CREDWELL

Project	173-179 Walker Street and 11-17 Hampden Street North Sydney
Report	Access Assessment Report (BCA 2022)
Reference	220720-r6-Access Assessment Report 2022
Date	23/10/2024
Client	CBUS Property Helen Rosen
Email	HRosen@cbusproperty.com.au

Figure 4- Lift Identification

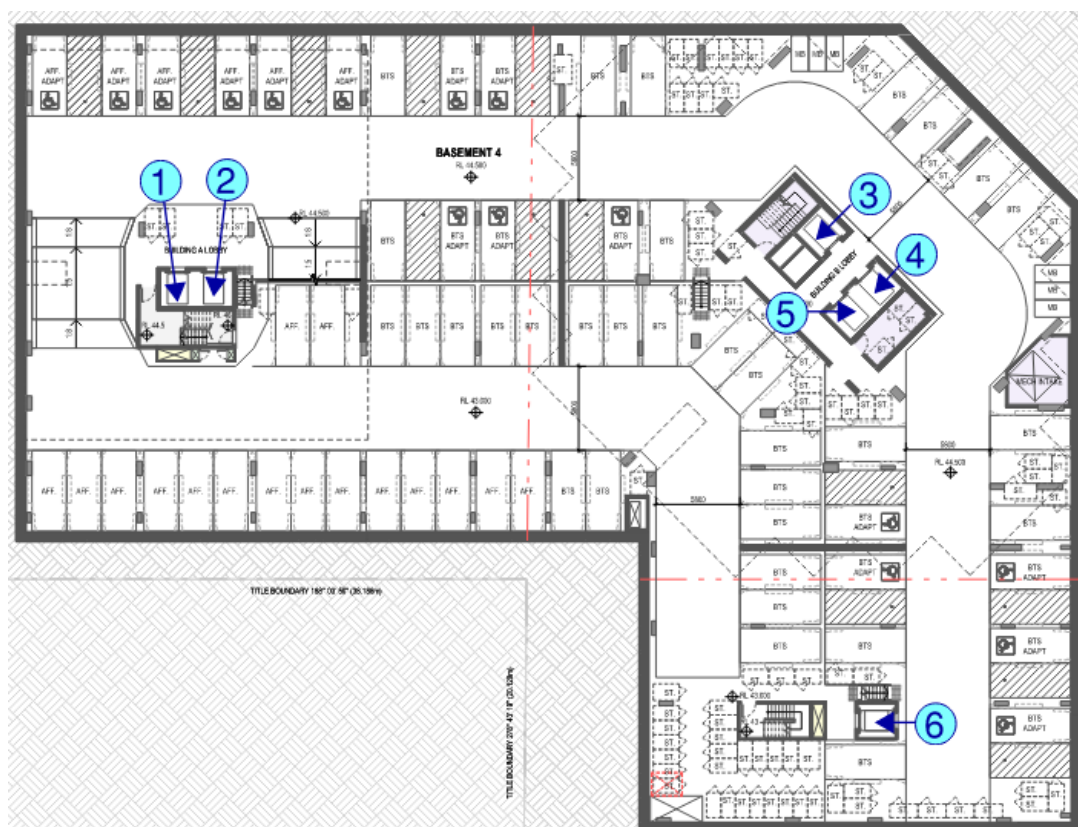
1. **Lift 1 and 2** - The lift travels from Basement 4 (having an FFL of 44.5m) to the Level 12 storey (having an FFL of 94.55m). Therefore, the lift travels 50.05m ($94.55 - 44.5 = 50.05$ m) which is greater than 12m.

2. **Lift 3** – The lift travels from Basement 4 (having an FFL of 44.5m) to the Level 27 storey (having an FFL of 144.35m). Therefore, the lift travels 99.85m ($144.35 - 44.5 = 99.85$ m), which is greater than 12m.

3. **Lift 4** T The lift travels from Basement 4 (having an FFL of 44.5m) to the Level 29 storey (having an FFL of 147.7m). Therefore, the lift travels 103.2m ($147.7 - 44.5 = 103.2$ m), which is greater than 12m.

4. **Lift 5** - The lift travels from Basement 4 storey (having an FFL of 44.5m) to Level 28 storey (having an FFL of 144.35m). Therefore, the lift travels 99.85m ($144.35 - 44.5 = 99.85$ m), which is greater than 12m.

5. **Lift 6**- The lift travels from the Basement 4 storey (having an FFL of 44.5m) to the Level 3 storey (having an FFL of 63.9m). Therefore, the lift travels 19.4m ($63.9 - 44.5 = 19.4$ m), which is greater than 12m.

Therefore, all lift floor dimensions shall consist of a minimum of 1400mm (W) x 1600mm(D) internal dimensions as per BCA Clause E3D8 (b).

Figure 9- Accessible path is required to all common areas of the building.

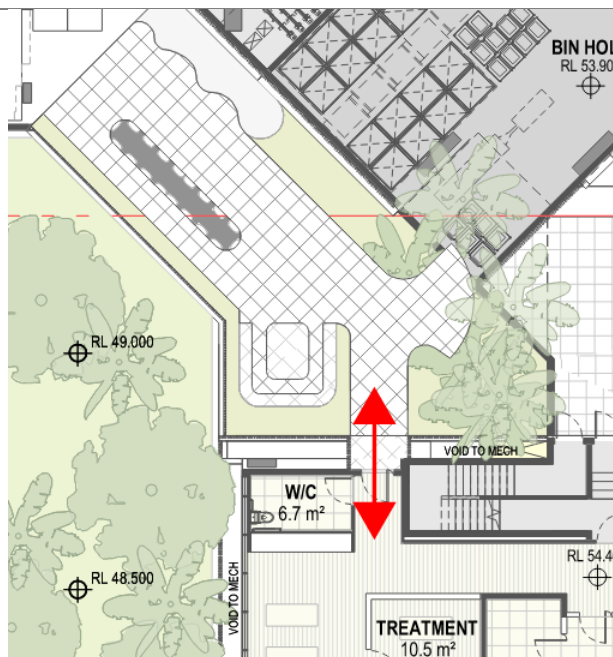
<p>5</p>	<p>Basement -1</p> <p>A common area is provided with a door to the gym and sauna area. The FFL of the outdoor area is not shown in the Basement 1 plan. Common areas of the Class 2 building shall be provided with accessible paths of travel based on BCA Clause D4D2(4)</p>	<p>D4D2</p>

Figure 10- Doors require minimum door clearances as per AS1428.1.2009 Figure 31

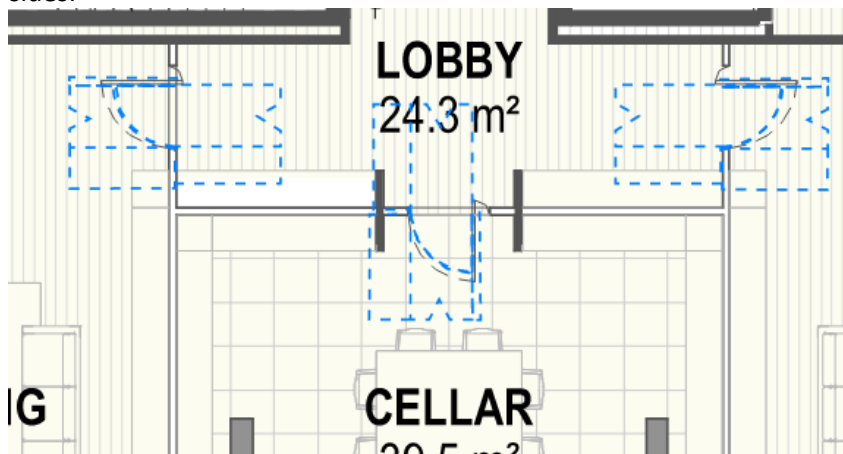
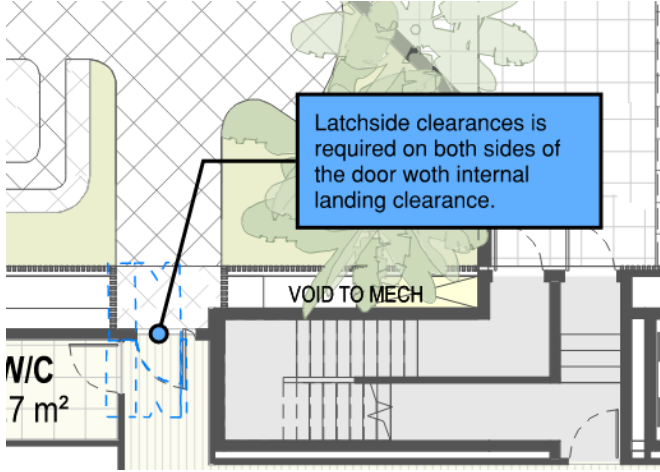
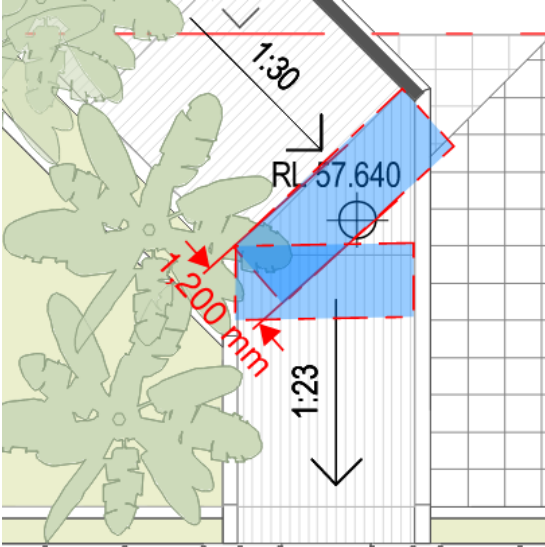
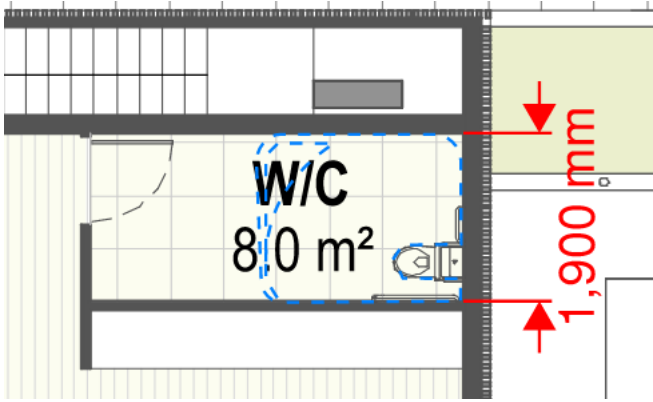
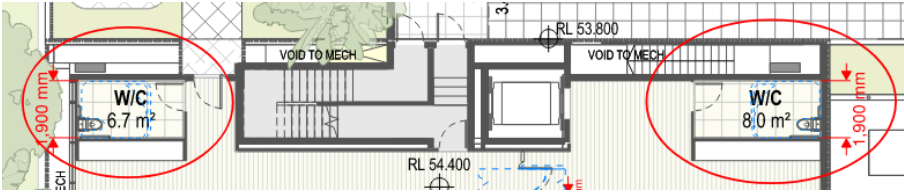
6 Building B2 Ground Floor

Three doors

- Lobby to the Private dining area,
- Lobby to the Lounge area and the private dining
- Entry door to the cellar area require door latchside clearances on both sides.

A latch side clearance of 510mm is to be provided when the door opens away from the user, and a 530mm latchside clearance is required when the door opens towards the user.

Figure 18- Minimum clearances to the appliances to be provided in accordance with AS1428.1.2009 Clause 15

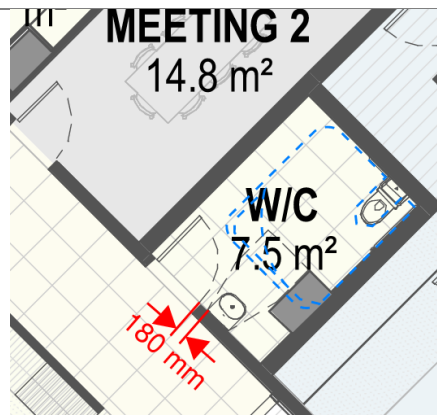
<p>Provide a WB with the clearance spaces based on AS1428.1.2009 Clause 15. The wash basin shall have a minimum clearance of 300mm from the door swing.</p>  <p><i>Figure 15- WC shall have minimum clearances and a WB shall be provided to the accessible facility.</i></p> <p>Note: The above comments apply to both Accessible sanitary facilities within the Gym and Studio area.</p>  <p><i>Figure 16- Accessible facilities at Gym and Studio areas.</i></p>	
	<p>Building 1- Ground Floor</p> <p>Provide the washbasins based on the above clause for the accessible sanitary facilities at the ground-level lounge and private dining areas.</p>  <p><i>Figure 17- Provide Wash basins to accessible sanitary facilities</i></p>	F4D5
12	<p>Building B1 Ground Level</p> <p>An accessible sanitary facility next to Meeting Room -2 shall be provided with circulation clearances for the appliances based on AS1428.1.2009. A column obstructs the WC clearance space, and the gap between the door swing is measured as 180mm instead of the 300mm maximum requirement.</p>	F4D5
